Service Action Number:
Q049

Engine Oil Pan Damage

Publication No.:	303-Q049v3
Model:	Defender Puma Diesel
Model Year:	2007 and 2008
VIN Range:	LD 732615 – LD 758400
Model:	Defender Puma Diesel (CKD)
Model Year:	2007 and 2008
VIN Range:	See table 1
Date of Issue:	20 March 2009
Expiry Date:	31 July 2010

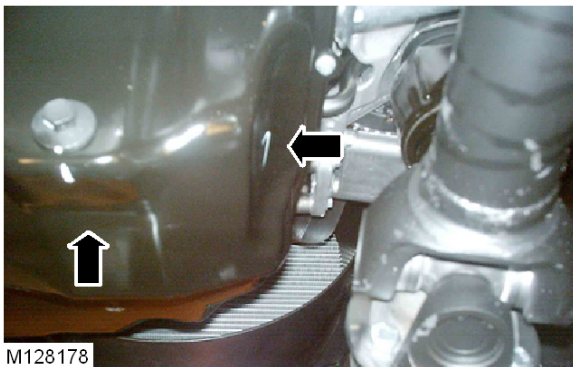
Item	Description	
1	<p>Note: The latest level oil pan has two indentations (see Fig. 1).</p> <p>Visually inspect the oil pan.</p> <ul style="list-style-type: none"> • If the oil pan is the latest level, no further action is required. • If not the latest level, carry out step 2. 	 <p>M128178</p>
		Fig. 1
2	Install a new oil pan (see Global Technical Reference (GTR) Workshop Manual, section: 303-01).

At the next service opportunity you are requested to visually inspect the oil pan and where necessary the latest level of the oil pan should be fitted. For the workshop procedure please refer to Appendix 1.
